Site Plan Review Committee (SPRC)
Staff Report for
4600 Fairfax Drive (Ballston Holiday Inn)
SPLN21-00008 (SP #57)

4600 Fairfax Drive (SPLN21-00008)
Ballston Holiday Inn Site
(RPC#s 14-053-055, -056, -023, 14-054-020, and -008)

**SITE PLAN REVIEW COMMITTEE
MEETING AGENDA**

Renderings of the North Building:

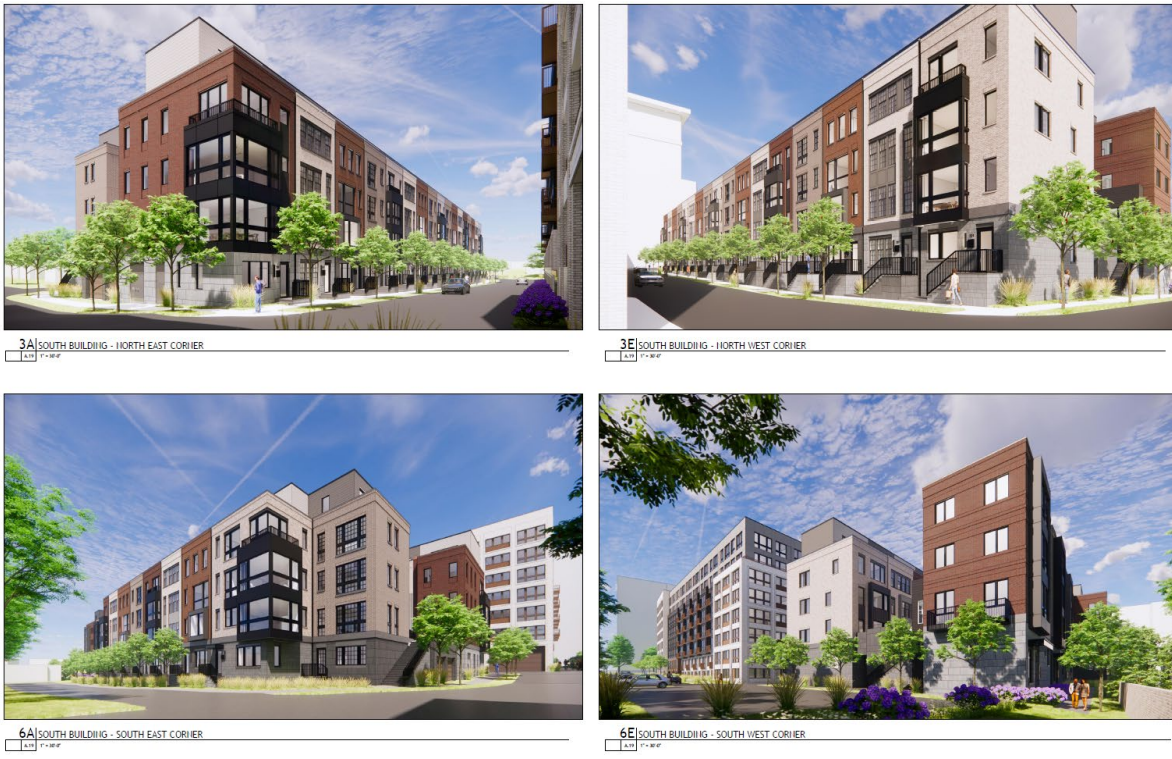
- The footprint of the North Building is significantly larger in scale than existing adjacent development. Reducing the building footprint or constructing two smaller buildings (in conjunction with a more direct or grid-style street layout) would provide a more pedestrian-oriented scale and design.

- Building height tapering along the western edge of the North Building, from tapering 7 stories down to approximately 5 stories, would better align with Sector Plan guidance.

- Active uses, such as dwelling units or residential amenity space, should be explored/added to the south side of the North Building, facing the South Building. The current proposal includes a ground level parking garage with little fenestration or pedestrian-oriented design elements.

Contextual Section (looking east):

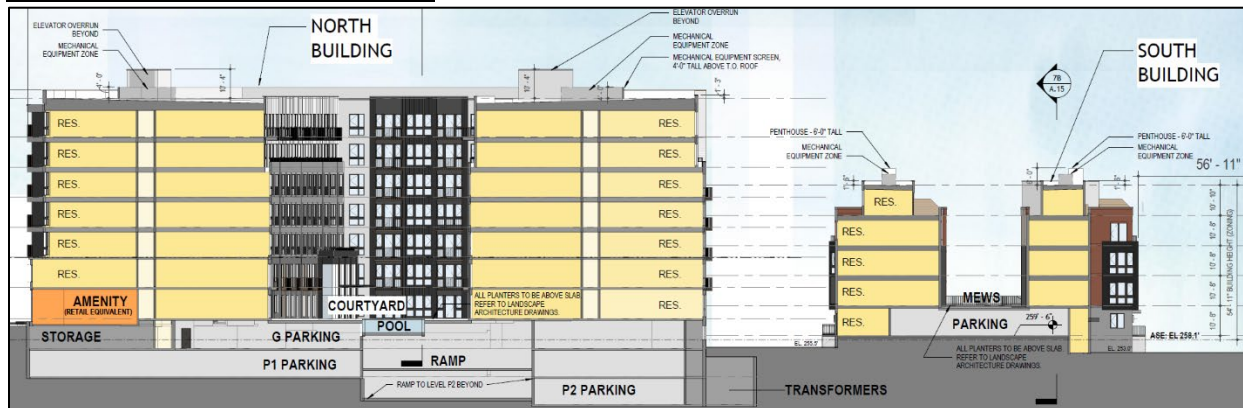
GLUP Note #23 applies to the adjacent “Peck/Staples” site (SP #401); however, given that the subject site is similarly located – in terms of proximity to existing lower density residential neighborhoods – staff encourages the applicant to follow the guidance of this Note. Note #23 states that “in order to provide an appropriate transition to adjacent residential neighborhoods, buildings on the southwest and western portions of the site shall consist of residential uses and have maximum heights of 50 feet.” Staff will work with the applicant on achieving appropriate tapering of building heights along the western edge of the site.

commercial and residential development projects adjacent to low-rise residential areas should include effective transition through the use of plant materials, tapering of building heights, balconies, open space, topography, walls and fencing.” Staff will be working with the applicant to discuss possible design revisions to achieve an appropriate transition between the site and the neighboring residential areas.
